Cust.Serv.-Techn.Office Motorcycles R50/R60/R69S/R27 München, 7. 10. 65  
VKT e/wi/be Group: Springs and shock abs. Nr. 2/65 (224) en.

Re: Seal rings on the front wheel swing arm bearing

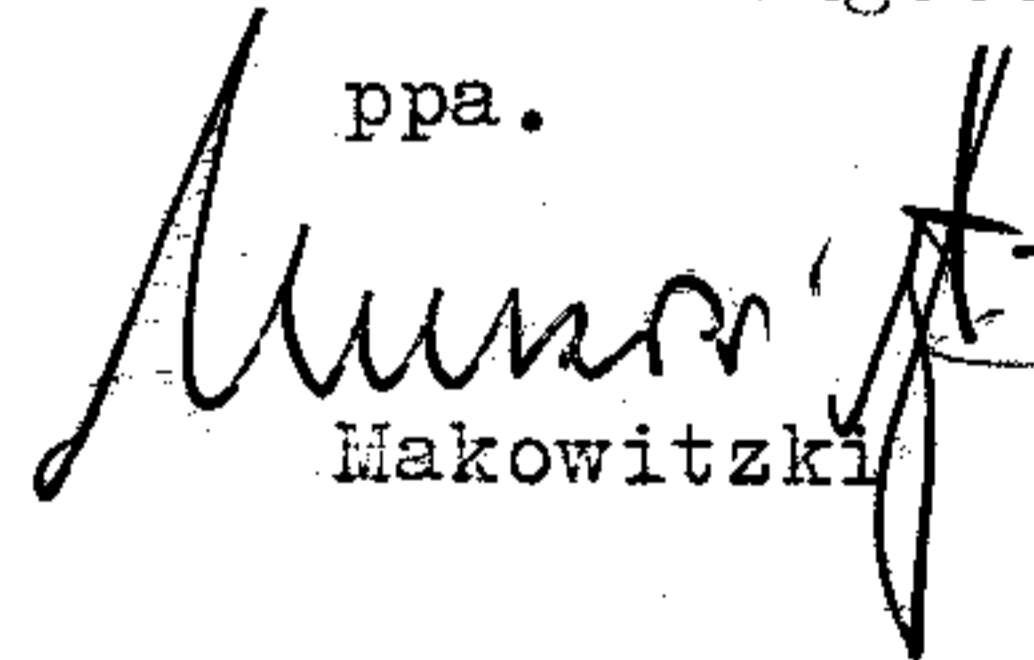
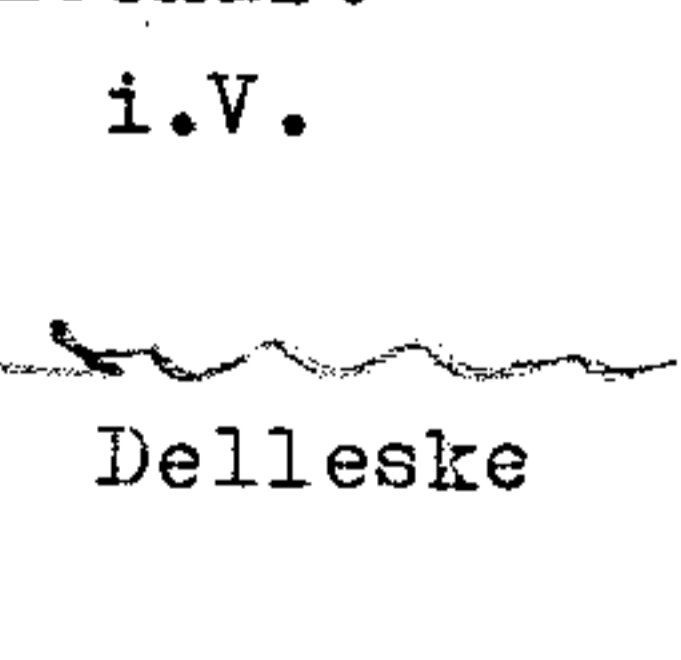
The hitherto installed seal rings, Part No. 20 00 331, have in some cases been pushed away from their seat and pressed out of the swing when lubricating at high pressures.

New seal rings with a metal capsule are installed as standard equipment, by which measure a pressing-out is avoided.

The new seal rings are installed from the following frame numbers:

639 796	(R 50)
627 5 6	(R 60)
679 497	(R 69 S)
383 866	(R 27)

The Part Number remains unchanged.
